CITY OF KIRKLAND

NE 85TH ST PED-BIKE CONNECTION 114TH AVE NE TO 6TH ST JOB NO. 37-24-PW CIP No. STC1070000

ADDENDUM No. 1 **TO THE PLANS, SPECIFICATIONS, PROPOSAL AND CONTRACT**

Issued This Date: Friday, January 17, 2025
Bid Opening: **Unchanged – February 5, 2025**
Place of Opening: City Hall, Council Chambers

DWG. NO. DP3

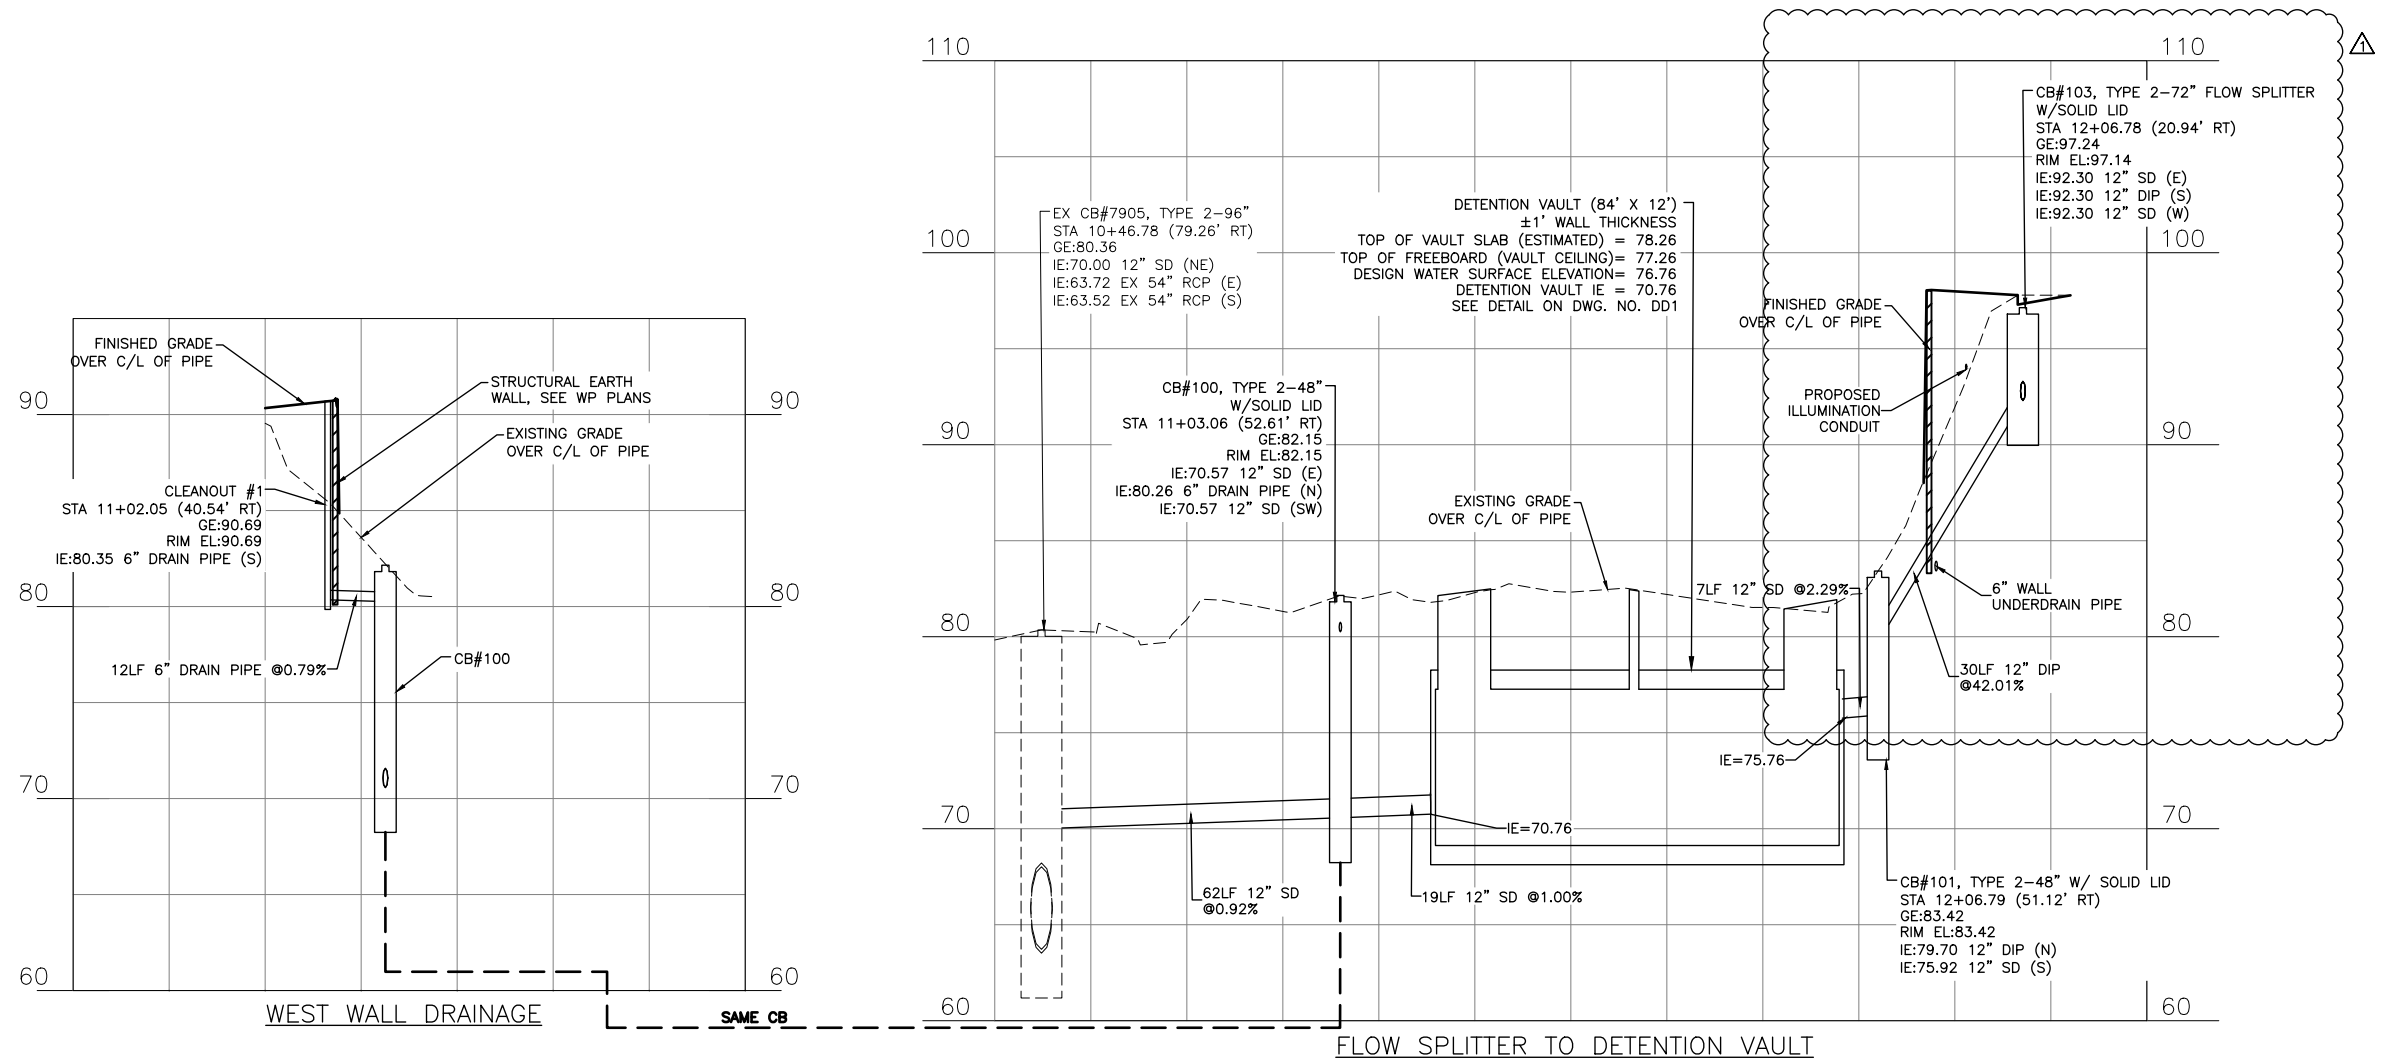
Description: Sheets DR1, DR2, DR3, DP1, DP3, DP4, DD1, DD2, WP1 - Replace in their entirety with the revised sheets, sheets 21-24, 26-29, 66 which are included as an attachment to this addendum

FILE	ENGR.	REVIEW	SCALE	DATE
DP3	##	##	AS SHOWN	JANUARY 2025
△	DRAINAGE PROFILE UPDATE		TWC	VWW 1/17/2025
NO.	REVISION	BY	REVIEW	DATE

DWG. NO. DP4

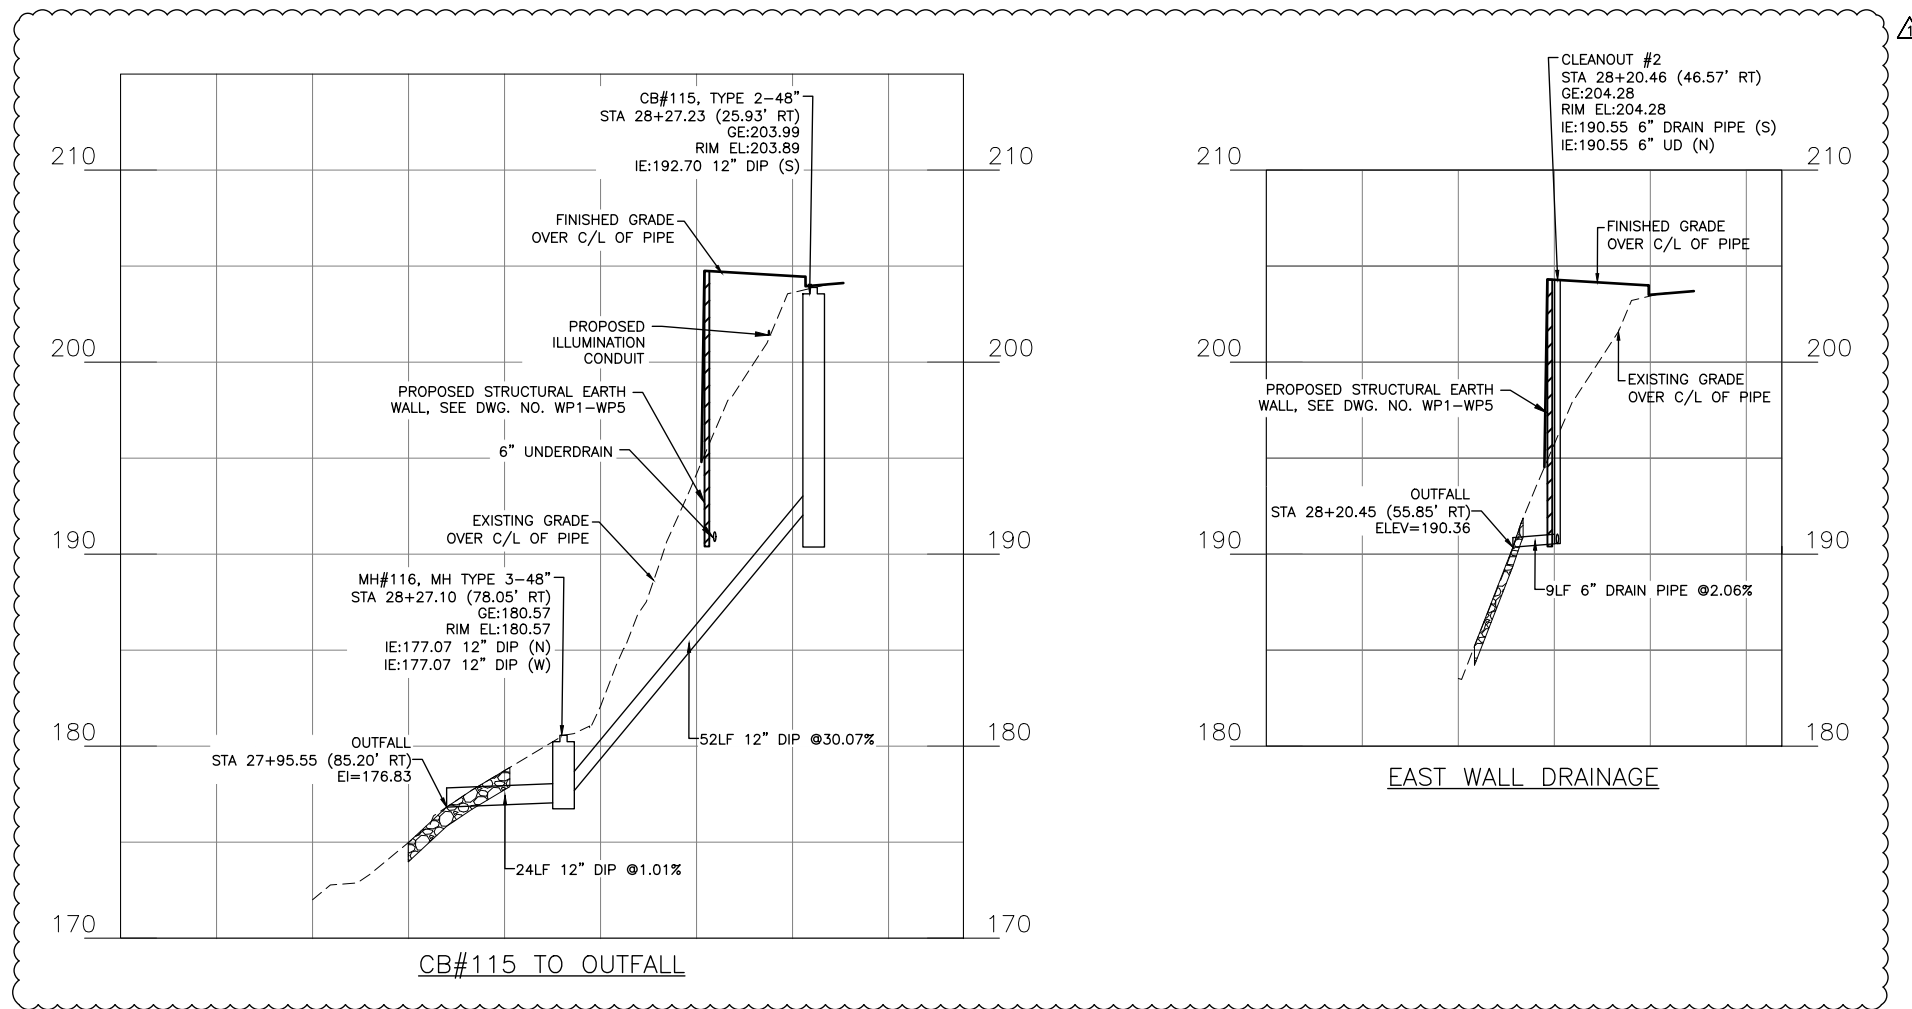
FILE	ENGR.	REVIEW	SCALE	DATE
DP4	##	##	AS SHOWN	JANUARY 2025
△	DRAINAGE PROFILE UPDATE		TWC	VWW 1/17/2025
NO.	REVISION	BY	REVIEW	DATE

DWG. NO. DD2

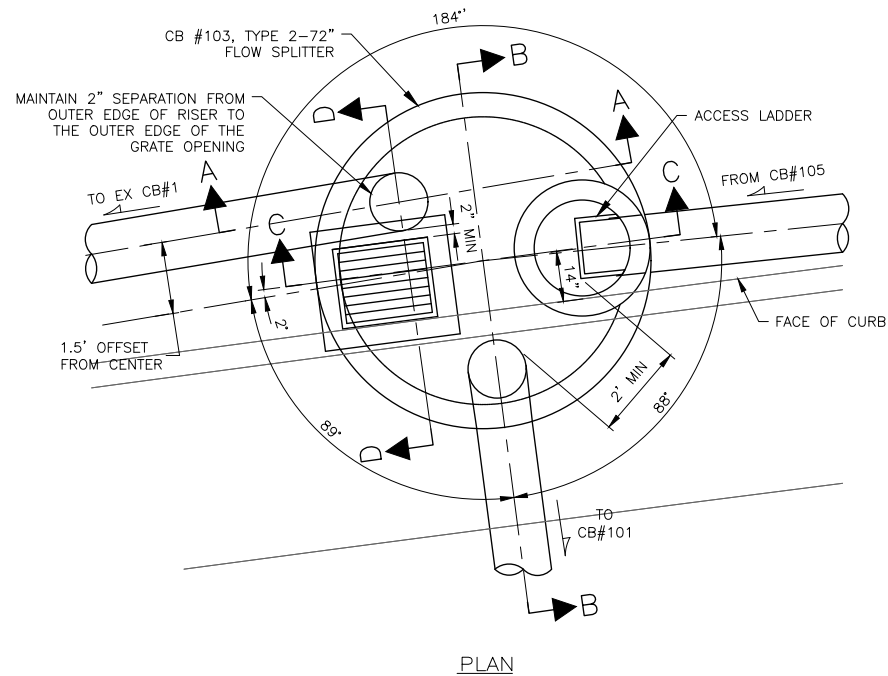
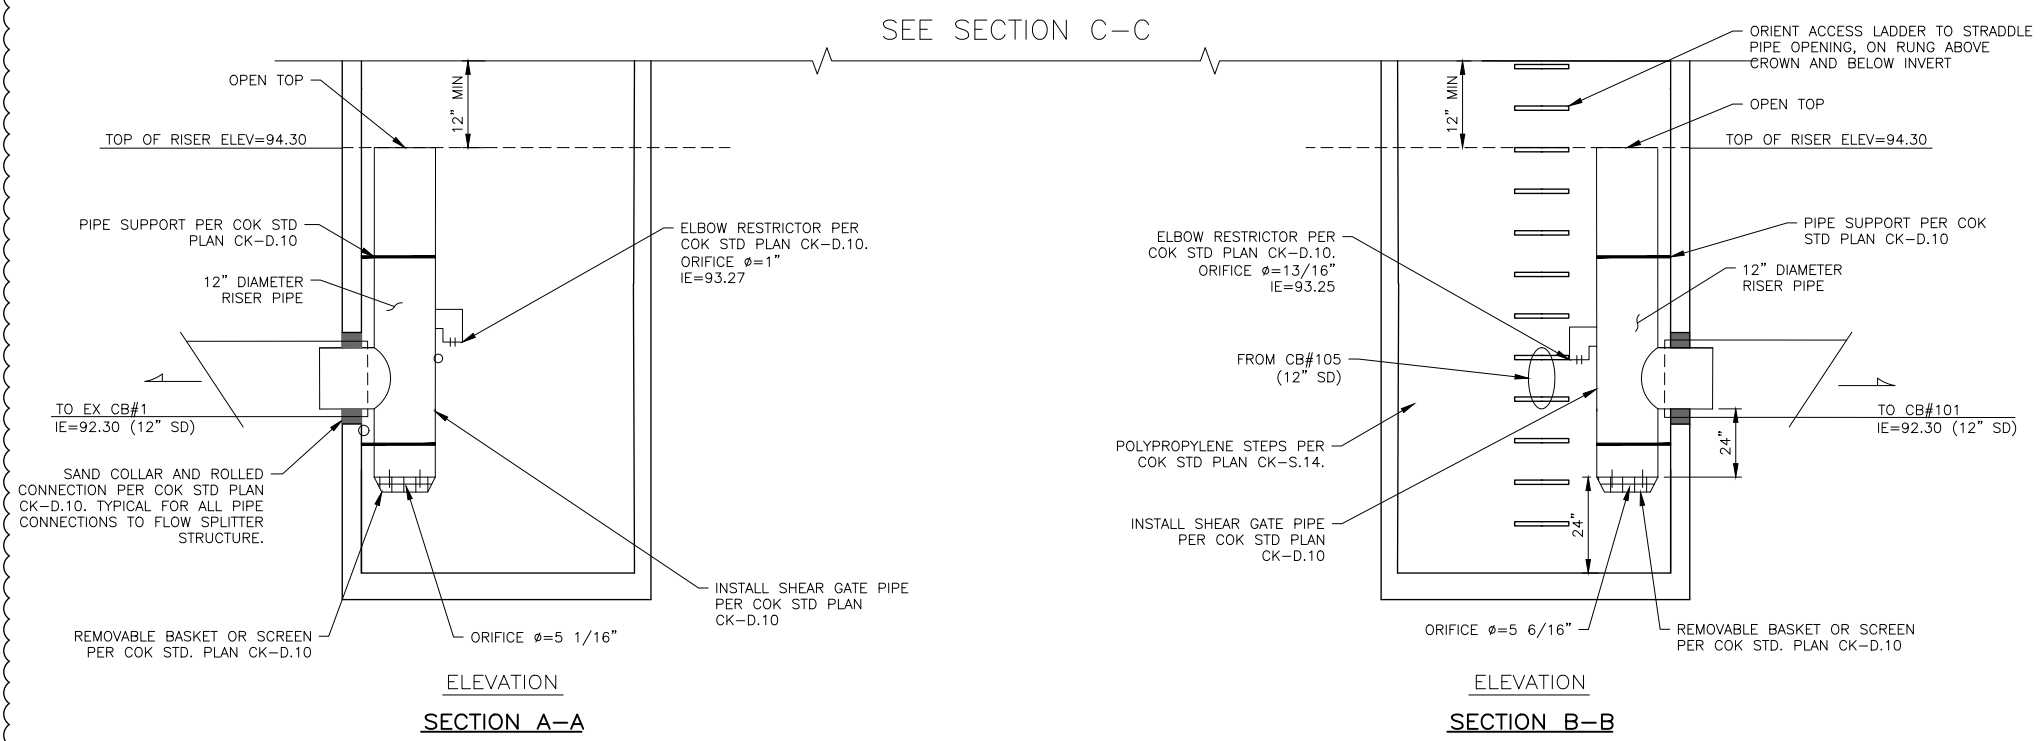
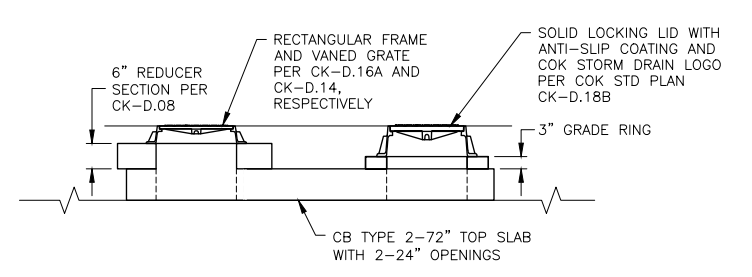
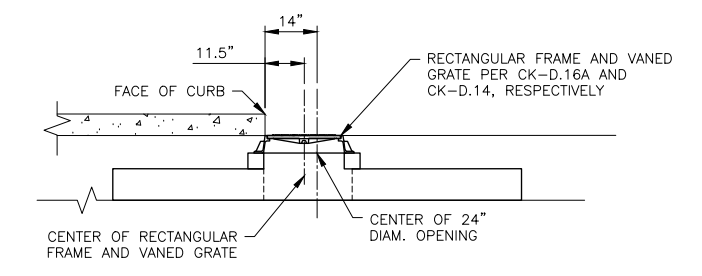
FILE	ENGR.	REVIEW	SCALE	DATE
DD2	##	##	AS SHOWN	JANUARY 2025
ENERGY DISSIPATION PAD DETAIL FLOW SPLITTER DETAIL UPDATE			TWC	VWW 1/17/2025
NO.	REVISION	BY	REVIEW	DATE

DWG. NO. WP1

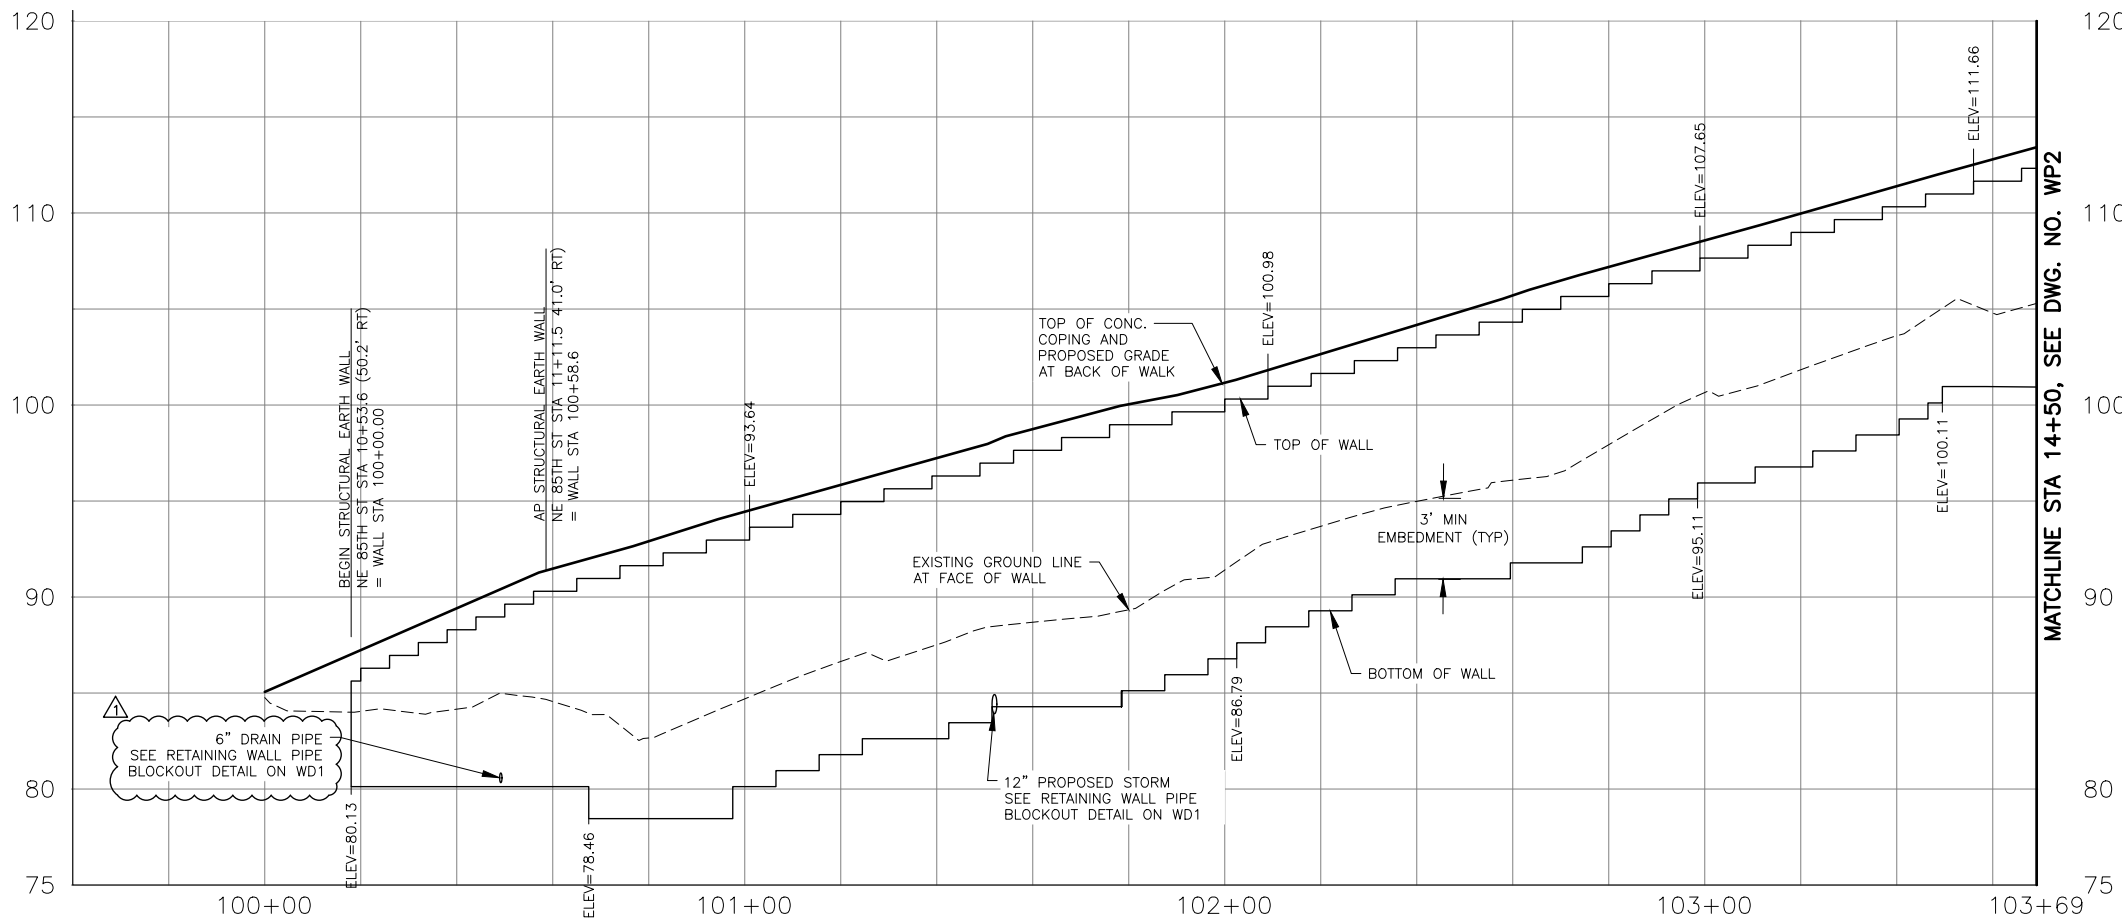
FILE	ENGR.	REVIEW	SCALE	DATE
WP1	##	##	AS SHOWN	JANUARY 2025
Δ	UPDATE TO PIPE CALLOUT	TWC	VWW	1/17/2025
NO.	REVISION	BY	REVIEW	DATE
